THE TOWNHOMES AT BRADLEY CROSSROADS

SITE DEVELOPMENT
 PLAN
 COVER SHEET

Site Development Plan

EPC PROJ NO. PPR1846

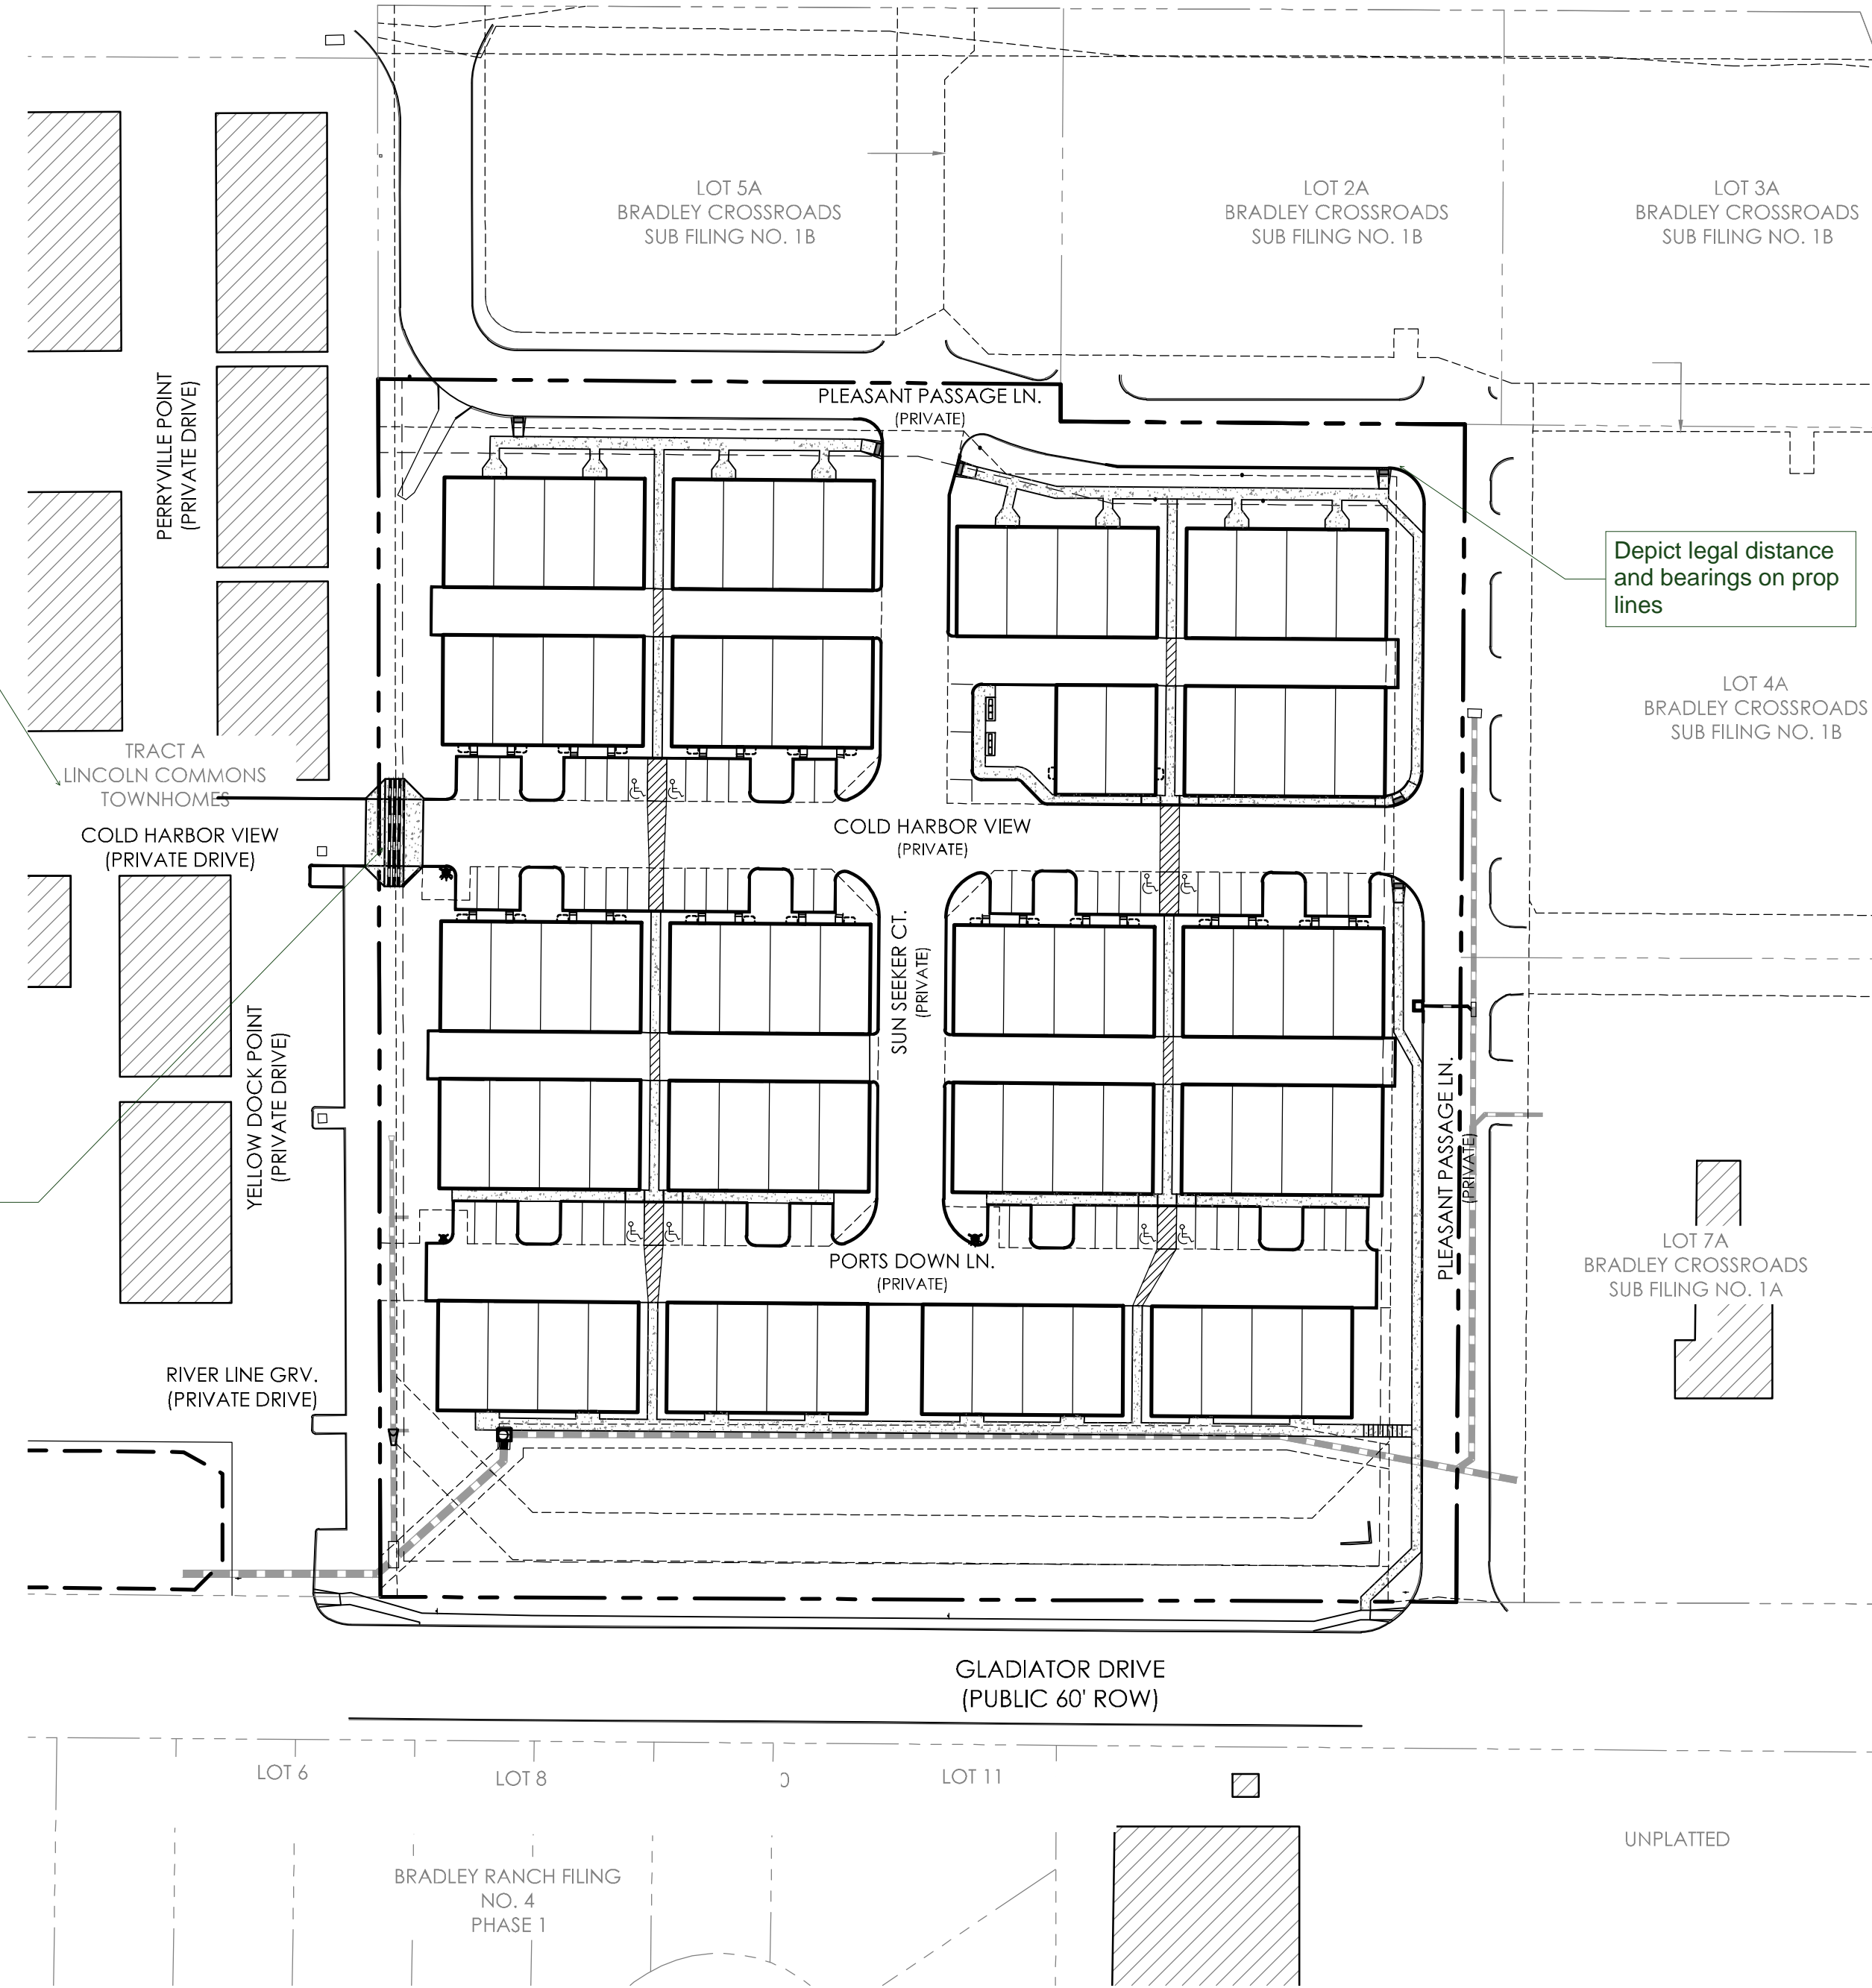
NO SIA is required with a Town Home (TH) plat- A TH plat does not plat lots it create units all improvements should be tied to the SDP as a TH plat is not required the units could be rented with the SDP and not platted for sale.

Add zoning adjacent to development- No buffer is required adjacent to multi-family; it is required adjacent to SF or com zoning.

This is restricted as no thru access per adjacent plat.

COVERAGE DATA	how many units? Are they all 3 bedrooms?
TOWNHOME BUILDINGS	38,640 SF - 16.9%
PAVEMENT (PARKING/WALK)	124,281 SF - 54.5%
LANDSCAPING	65,320 SF - 28.6%
TOTAL AREA	228,241 SF 100.0% = 5.240± ACRES
PARKING DATA	Multi Family Required: 1.7 SPACES / 1 UNIT = 1.7 X 78 = 133
Multi Family Required:	1.7 SPACE / 3 UNITS = 78 / 3 = 6
Handicap Required:	= 6
TOTAL SPACES REQUIRED:	= 159
PROVIDED:	= 156
GARAGES:	= 65
OUTSIDE PARKING (GUEST):	= 8
VAN ACCESSIBLE HANDICAP:	= 8
TOTAL SPACES PROVIDED:	= 221 SPACES
BUILDING TYPE	Identify unit number total, identify units as plus guest 1 space per 3 unit three bedrooms. (parking is calculated from bedrooms-recheck count after info is provided) 3 bedrooms require 2 parking spaces
BUILDING AREA - 3,864 SF	
TWO STORY - TYPE II-B	
NOT FIRE SPRINKLED / NO FIRE WALLS	
BUILDING HEIGHT	
40 FT MAX. (TWO STORY)	
SET BACKS	
25' FRONT (PLEASANT PASSAGE VIEW & GLADIATOR DRIVE)	
15' SIDE

FAE should be submitted with this

**SITE DEVELOPMENT
PLAN
SITE PLAN**

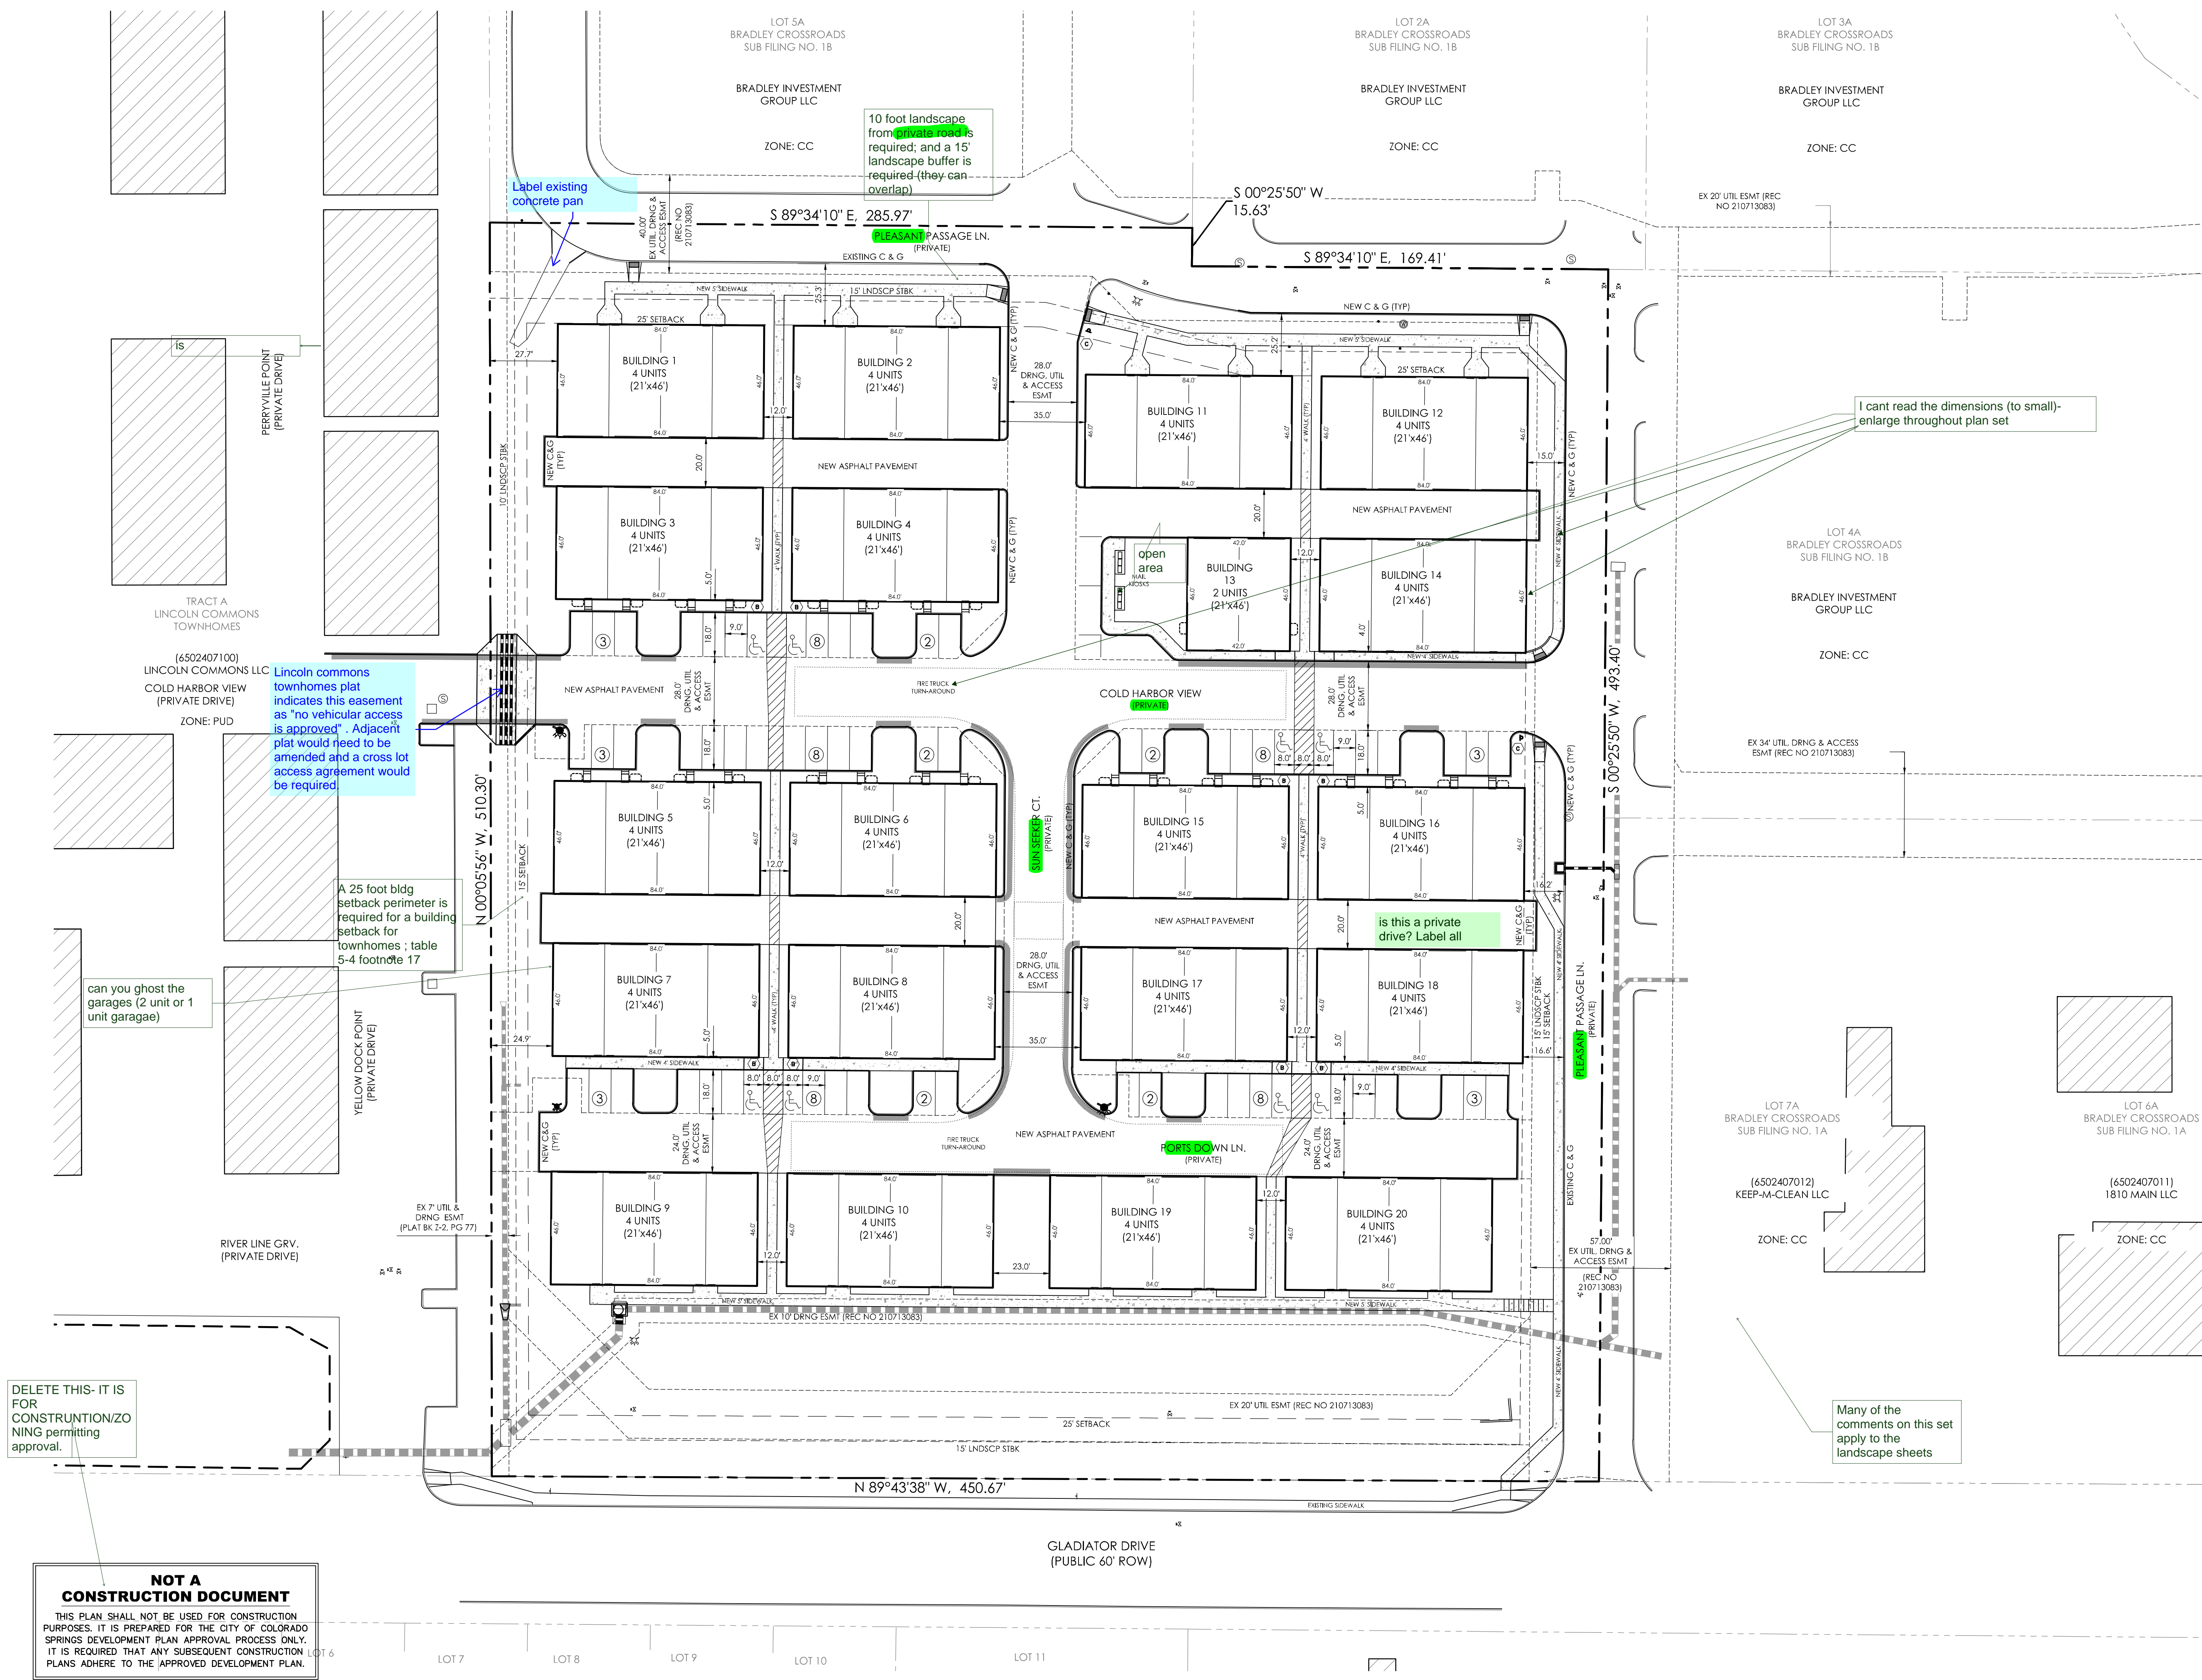
Label existing concrete pan

10 foot landscape from private roads required; and a 15' landscape buffer is required (they can overlap)

I cant read the dimensions (to small)-enlarge throughout plan set

Lincoln commons townhomes plat indicates this easement as "no vehicular access is approved". Adjacent plat would need to be amended and a cross lot access agreement would be required.

A 25 foot bldg setback perimeter is required for a building setback for townhomes ; table 5-4 footnote 17

can you ghost the garages (2 unit or 1 unit garages)

is this a private drive? Label all

Many of the comments on this set apply to the landscape sheets

DELETE THIS- IT IS FOR CONSTRUCTION/ZONING permitting approval.
